## SCHEMATIC REVIEW

RE: QUIZNOS SUB  
Highland Commons Store #11466  
17002 Jefferson Hwy. Ste. C  
Baton Rouge, LA 70817  
(Accepted 1.17.07)

#11466 SCHEMATIC  
1200 S.F.

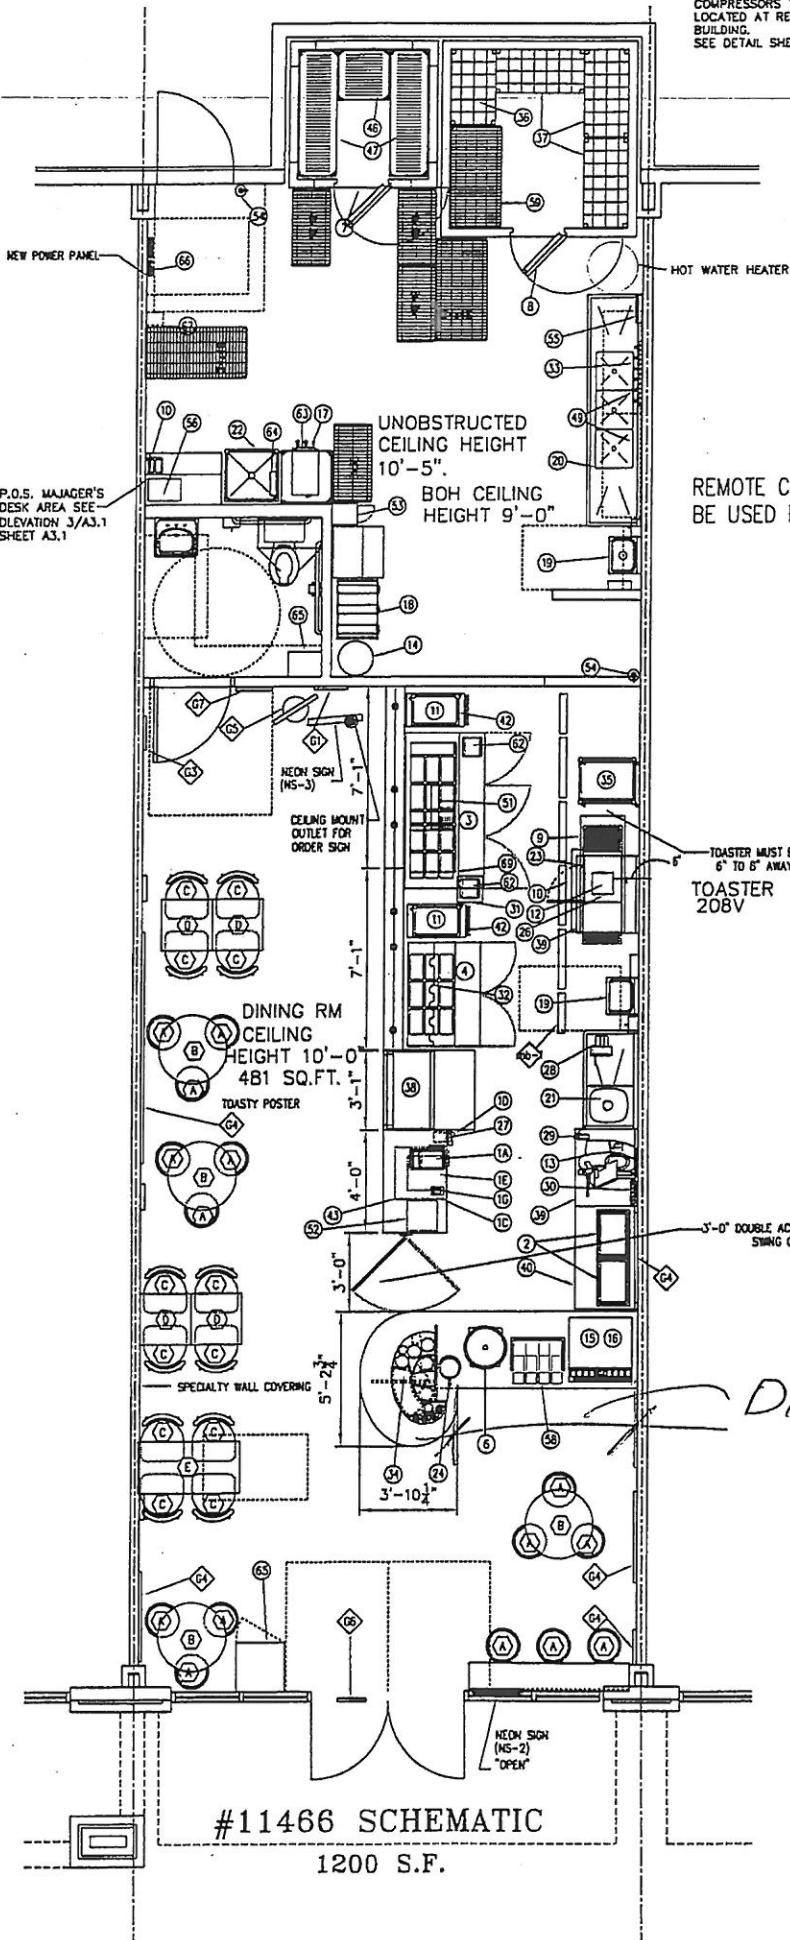
- g. **Remote compressors noted per the schematic. Verify.**
- h. **A 9'-6" high freezer is standard. Please complete the Kolpak worksheet and return it to our office. Construction documents will not be reviewed until the Kolpak worksheet has been received by the design and construction department.**

- i. **A 208V toaster is noted. Verify.**
- j. **Effective immediately- Place the toaster 6" to 8" away from the FRP to prevent the FRP from melting due to high temperatures from the toaster. \*\*\*Verify the clearance of the service area due to the toaster moving out 6" to 8".**

ALL REMOTE COMPRESSORS TO BE LOCATED AT REAR OF BUILDING. SEE DETAIL SHEET A4.1.

REMOTE COMPRESSORS WILL BE USED FOR THIS STORE.

TOASTER MUST BE LOCATED 6" TO 8" AWAY FROM FRP  
TOASTER 208V
